Form 504	
U. S. DEPARTMENT OF COMMERCE	
COAST AND GEODETIC SURVEY	
DESCRIPTIVE REPORT	
Type of Survey	SHORELINE
Field No.	Office No. T-12159
LOCALITY	
State	PUERTO RICO
General locality	EAST COAST
Locality	PUNTA LIMA TO
PLAYA DE HUMACAO	
1958 - 1962	
CHIEF OF PARTY	
M. L. Olivier, Photo Party 708	
V. Ralph Sobieralski, Tampa District Office	
LIBRARY & ARCHIVES	
DATE	1 JUL 1968

SUMMARY TO ACCOMPANY
DESCRIPTIVE REPORT T-12159

REVIEW REPORT T-12159
SHORELINE
February 1968

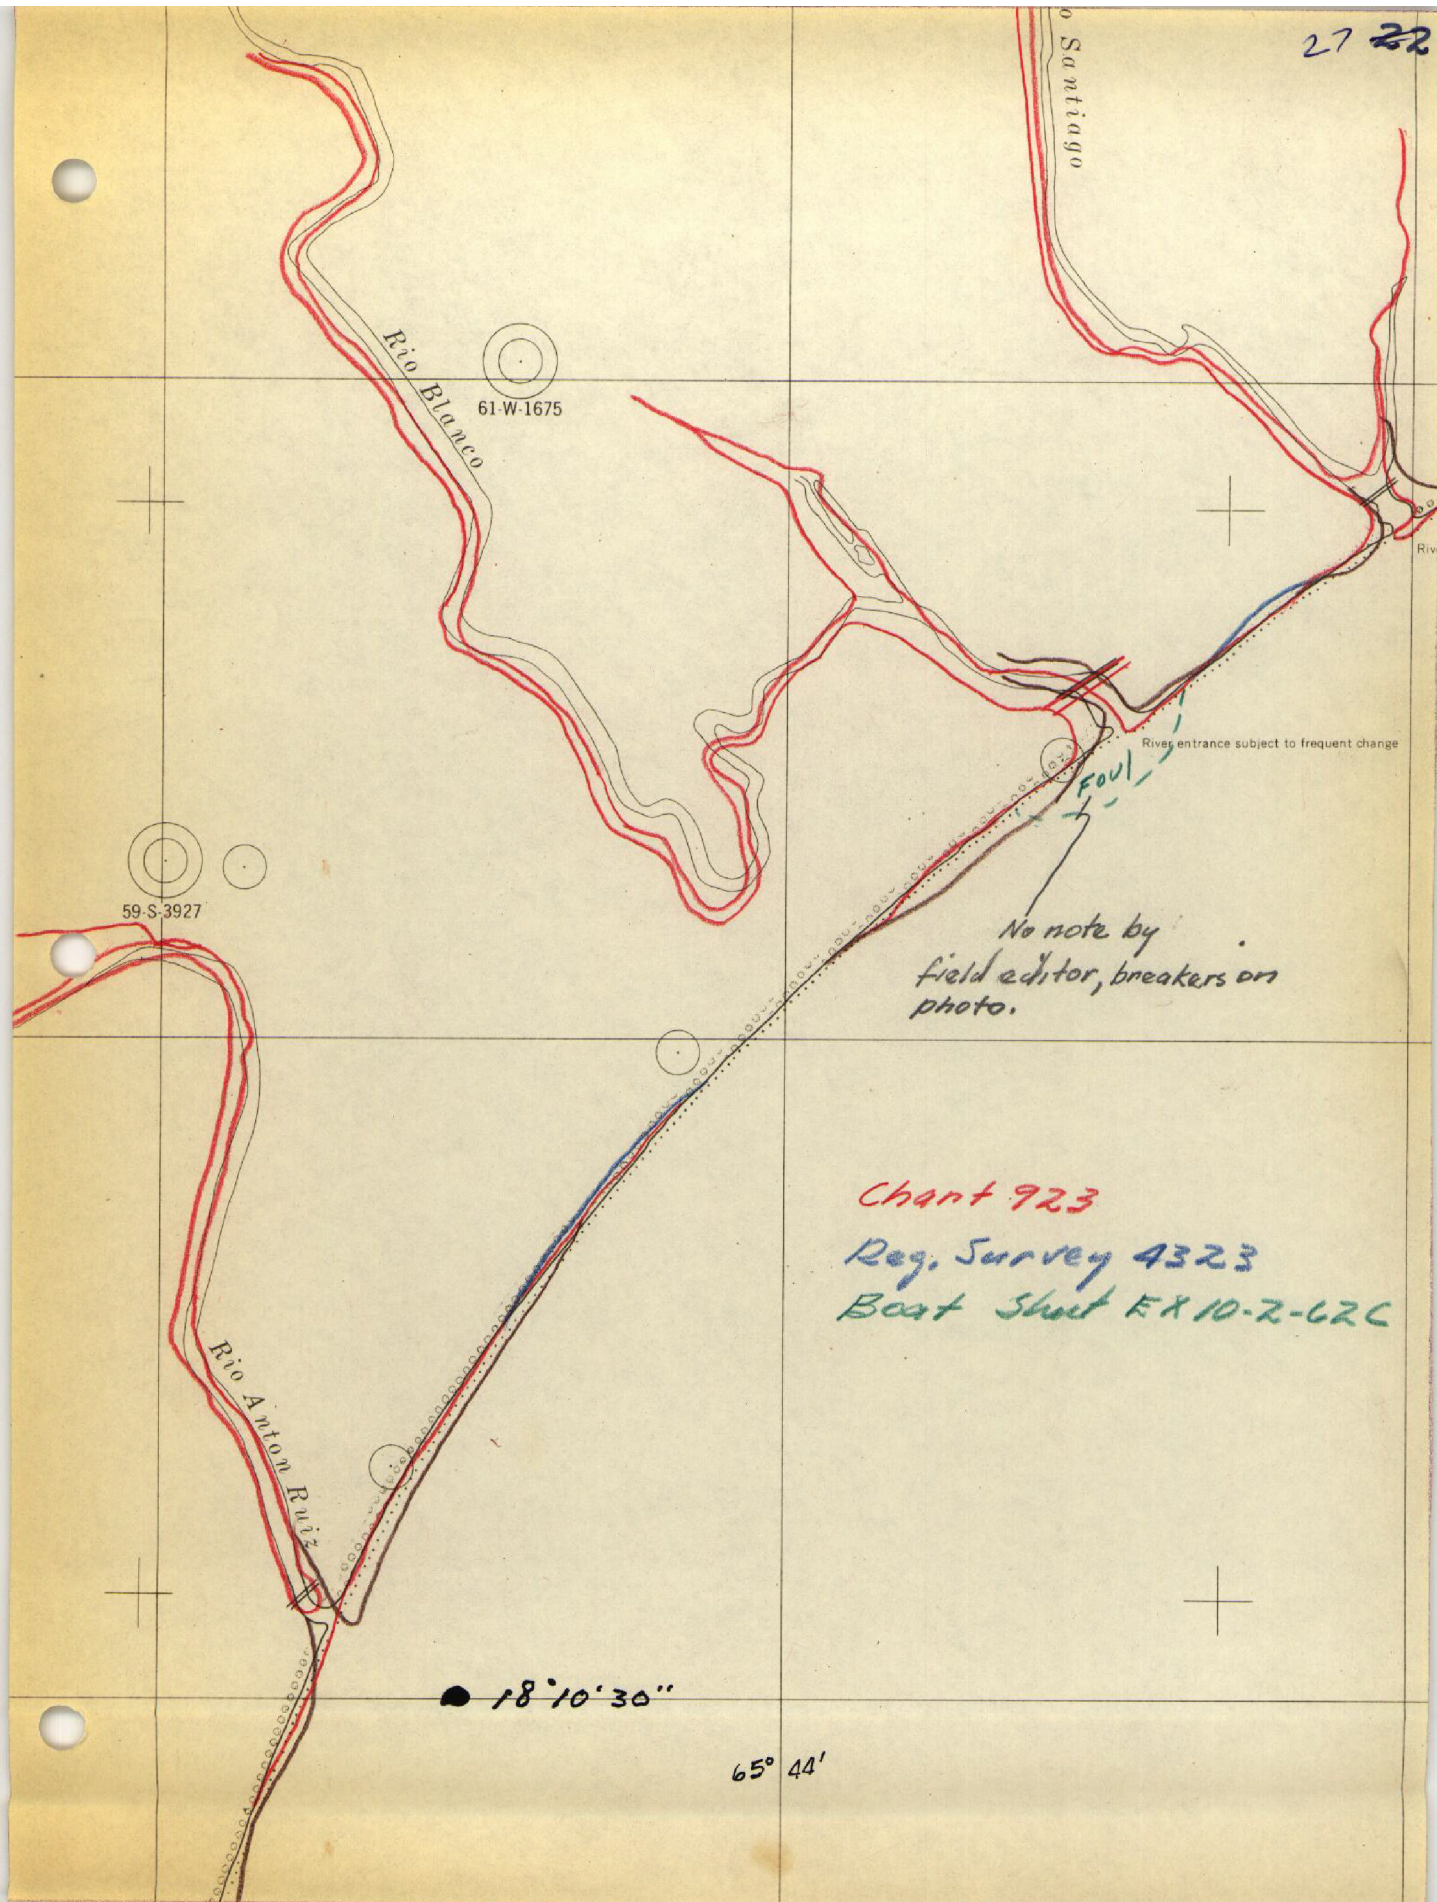
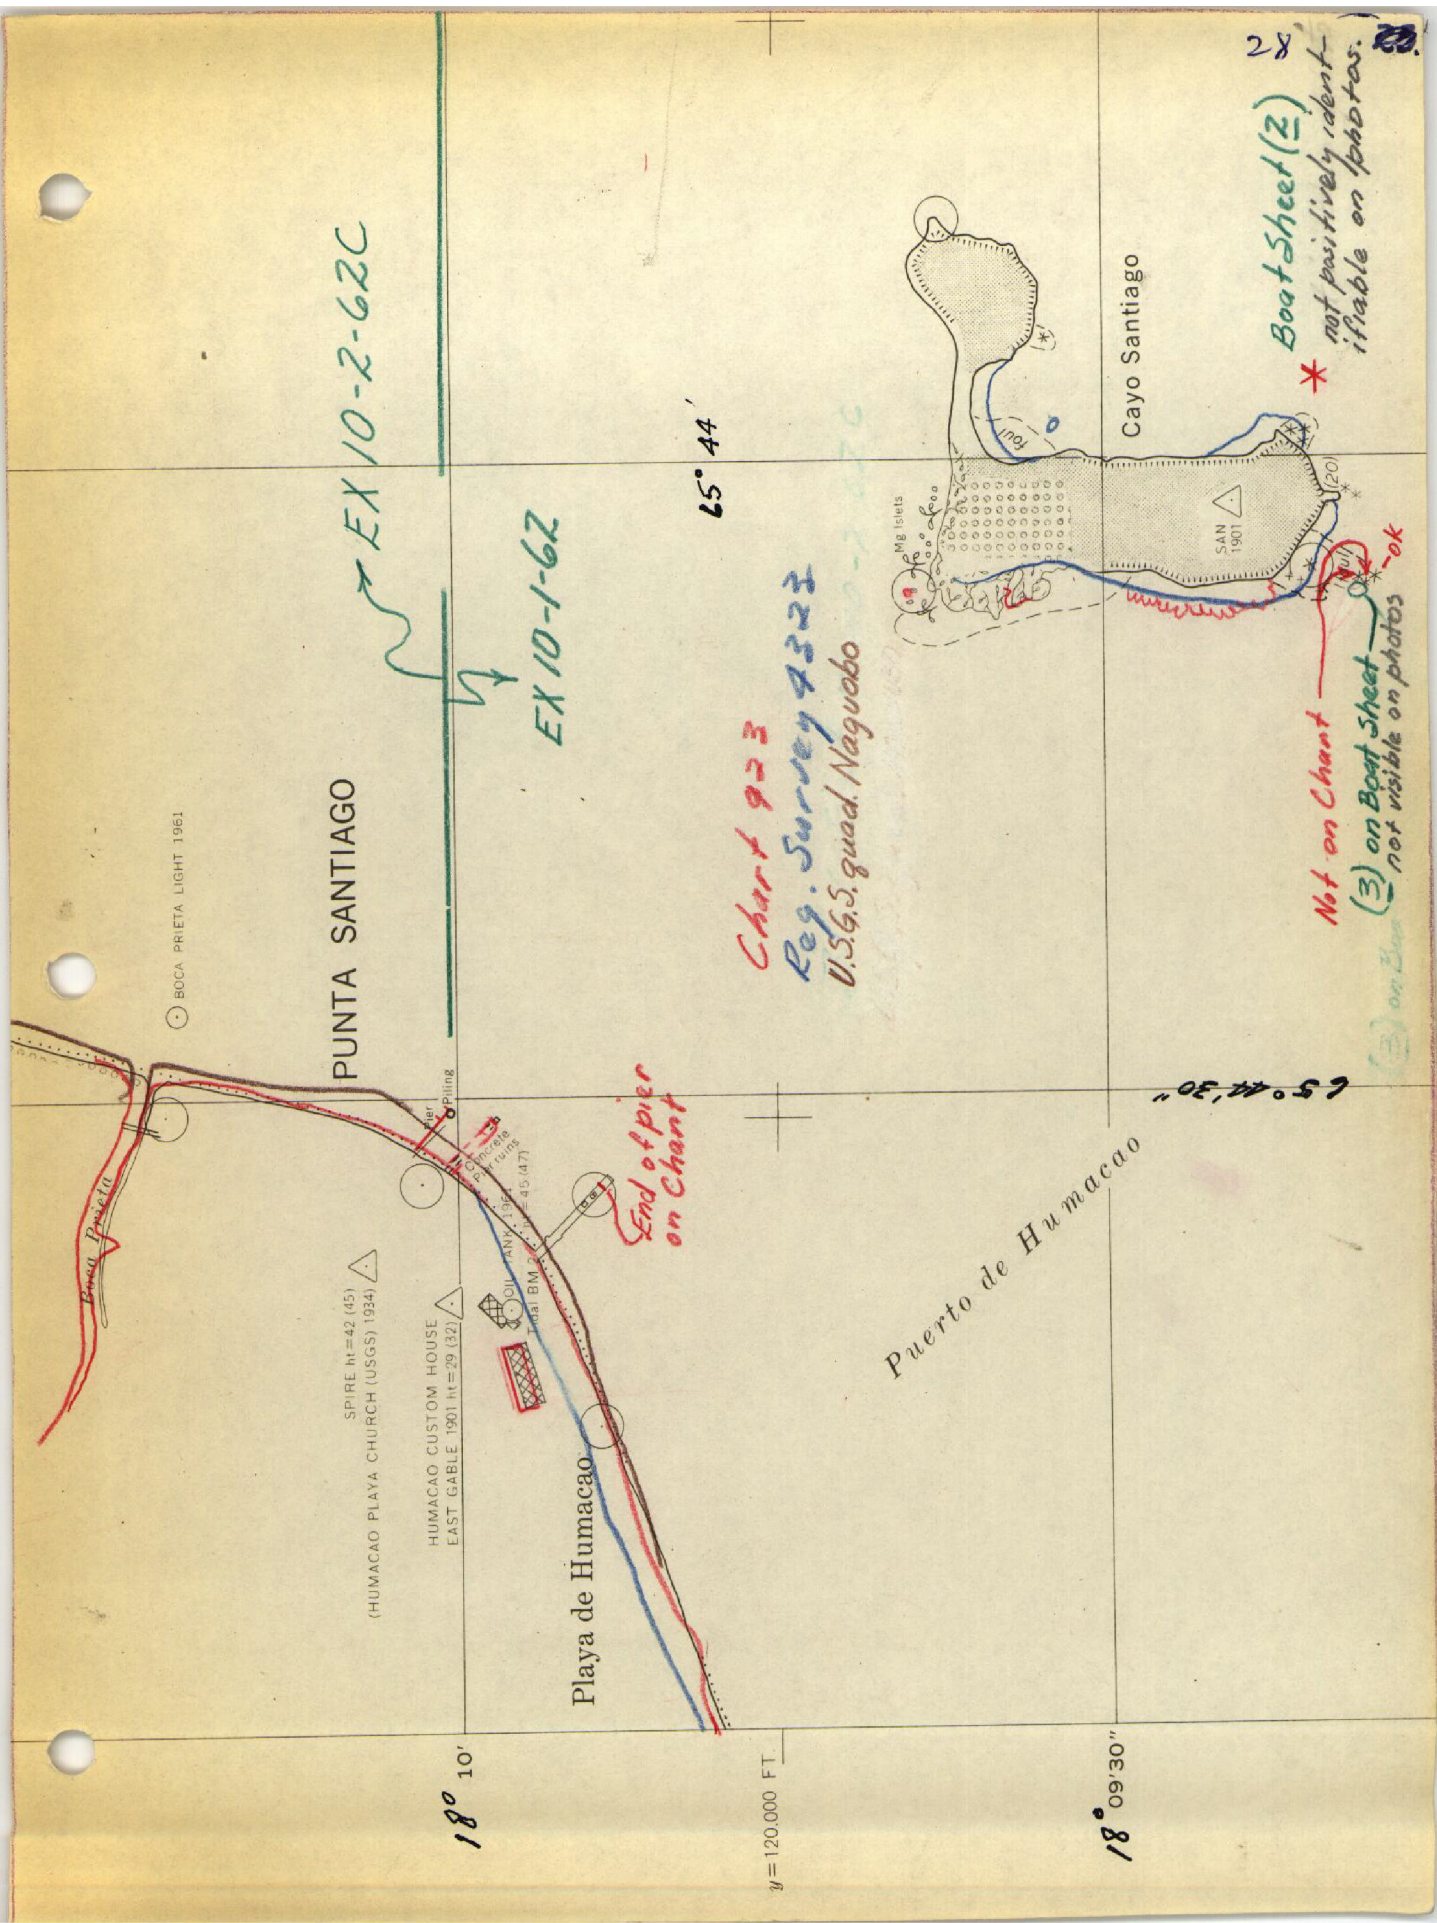
Sunken barge
in ruins

Not visible here on photos
595-3926, 3927. 61W 1675
Not on Boat Sheet

Not visible on photos.
Not noted by hydro.

Bares 1.0 at 1000
61/62 (something here on
photo, but?)

Rocks & displaced
on Chart

"Rock bares 1.0, 1100,
61/62"

End of pier
on Chart

28
Boat Sheet (2)
not positively ident-
ifiable on photos

Not on Chart
(3) on Boat Sheet
not visible on photos
